### **REMARKS/ARGUMENTS**

Appln. No. 09/987,217  
Amdt. dated Feb. 23, 2005  
Reply to Office Action of Feb. 7, 2005

**Amendments to the Drawings:**

Fig. 1 PRIOR ART

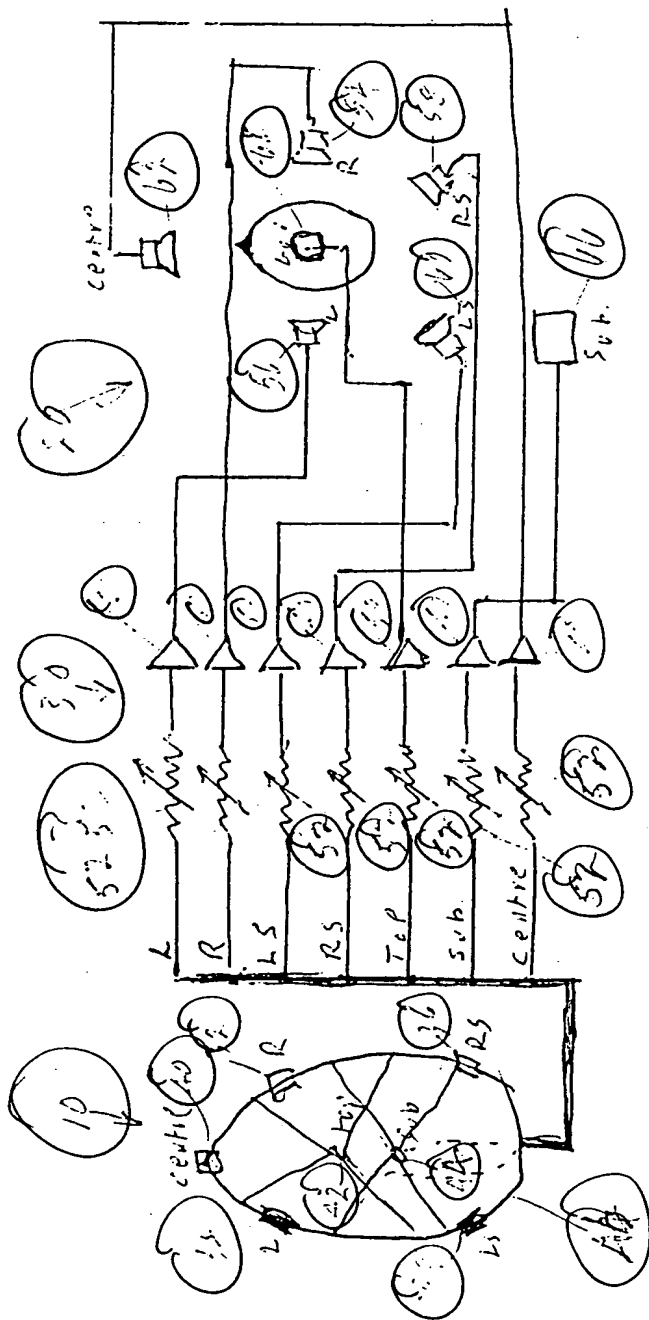
In the amended Figures, the current reference numerals have been replaced by larger reference numerals and the two figures separated into two pages for clarification purposes. In Figure 2, omitted reference numeral "80" has been entered. The figures have been appropriately renumbered as Figure 1 and Figure 2.

The attached sheets of drawings include changes to the reference numerals to Figures 1 and 2. In Figure 2, previously omitted reference numeral 80 has been added.
